## PCI-SIG ENGINEERING CHANGE NOTICE

<b>TITLE:</b>	Enhanced Allocation (EA) for Memory and I/O Resources
<b>DATE:</b>	Introduced: 19 March 2014 Updated: 23 October 2014 Final Approval: 23 October 2014
<b>AFFECTED DOCUMENT:</b>	PCI Local Bus Specification Revision 3.0, 3.1 PCI Code and ID Assignment Specification
<b>SPONSOR:</b>	Dave Harriman (Intel)

**Figure 6-1: Example Illustrating Application of Enhanced Allocation**

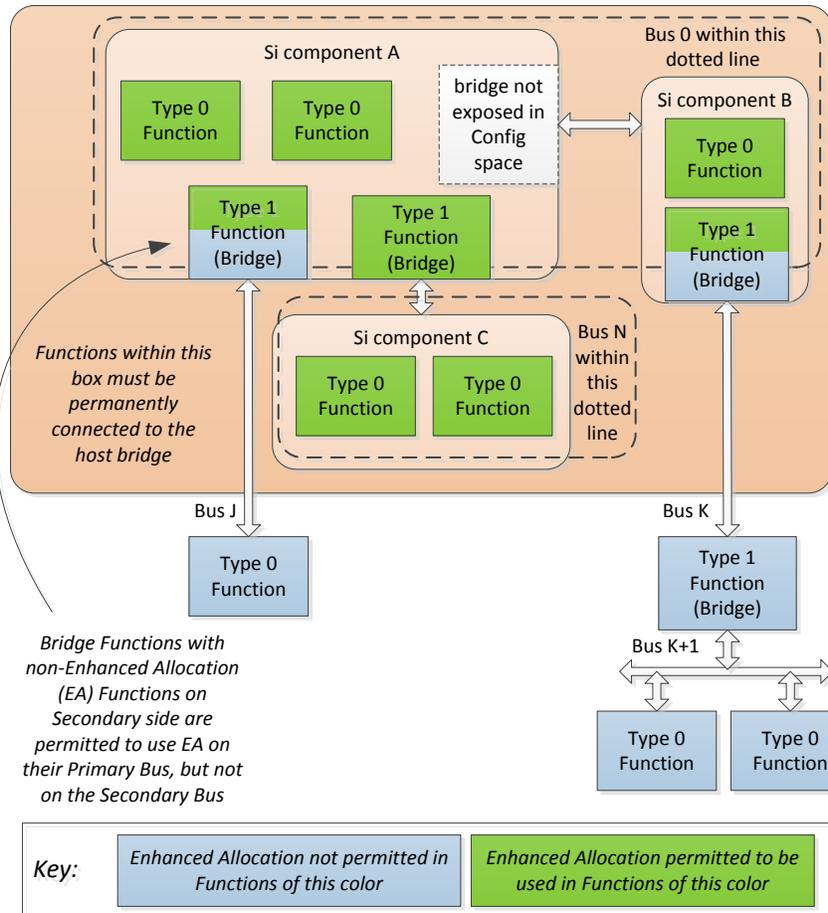
It is only permitted to apply EA to certain functions, based on the hierarchal structure of the functions as seen in PCI configuration space, and based on certain aspects of how functions exist within a platform environment (see **Figure 6-1**).

Only functions that are permanently connected to the host bridge are permitted to use EA. A bridge function (i.e., any function with a Type 1 Configuration Header), is permitted to use EA for both its Primary Side and Secondary Side if and only if the function(s) behind the bridge are also permanently connected (below one or more bridges) to the host bridge, as shown for “Si component C” in Figure 6-1.

A bridge function is permitted to use EA only for its Primary Side if the function(s) behind the bridge are not permanently connected to the bridge, as with the bridges above Bus J and Bus K in Figure 6-1, and in this case the non-EA resource allocation mechanisms in the Type 1 Header for Bus numbers, MMIO ranges and I/O ranges are used for the Secondary side of the bridge. System software must ensure that the allocated Bus numbers are within the range indicated in the Fixed Secondary Bus Number and Fixed Subordinate Bus Number registers of the EA capability. System software must ensure that the allocated MMIO and I/O ranges are within ranges indicated with the corresponding Properties in the EA capability for resources to be allocated behind the bridge. For Bus numbers, MMIO and I/O ranges behind the bridge, hardware is permitted to indicate overlapping ranges in multiple bridge functions, however, in such cases, system software must ensure that the ranges actually assigned are non-overlapping.

For a bridge function that is permitted to implement EA based on the rules above, it is permitted, but not required, for the bridge function to use EA mechanisms to indicate resource ranges that are located behind the bridge Function (see Section 6.9.1.2). In the example shown in in **Figure 6-1**, the bridge above Bus N is permitted to use EA mechanisms to indicate the resources used by the two functions in “Si component C”, or that bridge is permitted to not indicate the resources used by the two functions in “Si component C”. System firmware/software must comprehend that such bridge functions are not required to indicate inclusively all resources behind the bridge, and as a result system firmware/software must make a complete search of all functions behind the bridge to comprehend the resources used by those functions.

**Figure 6-5: Format of Entry for Enhanced Allocation Capability**

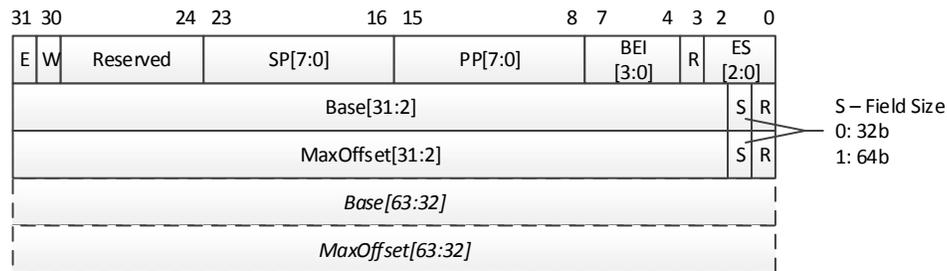
The Figure 6-5 illustrates the format of a complete Enhanced Allocation entry for a Type 0 function. For the Base and MaxOffset fields, bit 1 indicates if the field is a 32b (0) or 64b (1) field.

The value in the Base field ([63:2] or [31:2]) indicates the DW address of the start of the resource range. Bits [1:0] of the address are not included in the Base field, and must always be interpreted as 00b.

The value in the Base field plus the value in the MaxOffset field ([63:2] or [31:2]) indicates the address of the last included DW of the resource range. Bits [1:0] of the MaxOffset are not included in the MaxOffset field, and must always be interpreted as 11b.

For the Base and MaxOffset fields, when bits [63:32] are not provided then those bits must be interpreted as all 0's.

Although it is permitted for a Type 0 Function to indicate the use of a range that is not naturally aligned and/or not a power of two in size, some system software may fail if this is done. Particularly for ranges that are mapped to legacy BARs by indicating a BEI in the range of 0 to 5, it is strongly recommended that the Base and MaxOffset fields for a Type 0 Function indicate a naturally aligned region.
